Applicant: Archer et al.
Application Serial No.: 10/779,485
Filing Date: February 13, 2004
Docket No.: 577-526 CON
Page 10

REMARKS

Amendments to the Drawings:

FIG. 6

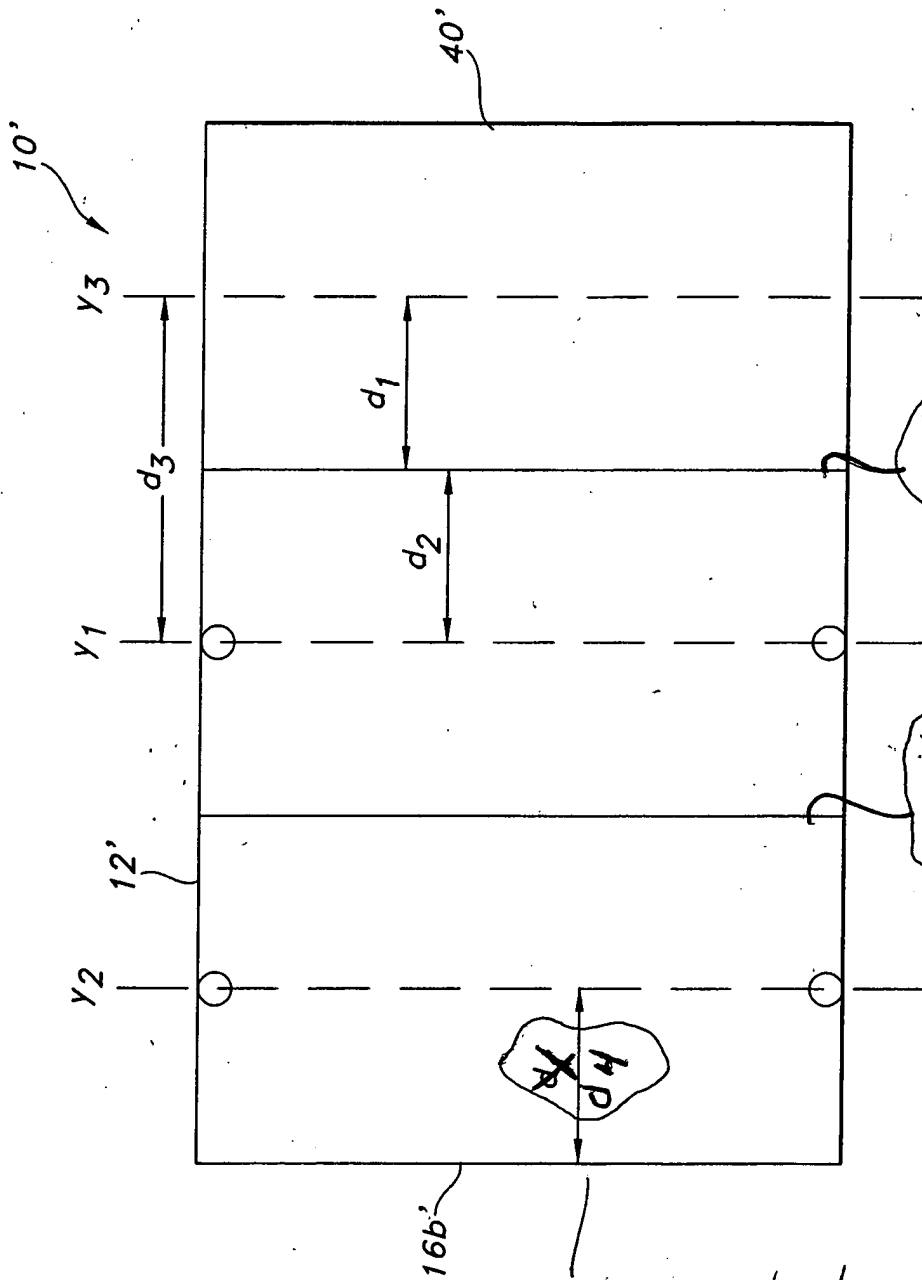
The attached sheet of drawings includes changes to Figure 6. In Figure 6, previously omitted elements 16a' and 16c' have been added. Reference numeral "d₁" was changed to --d₄--.

Element
16a' added

Element
16c' added

Element d,
changed to d4
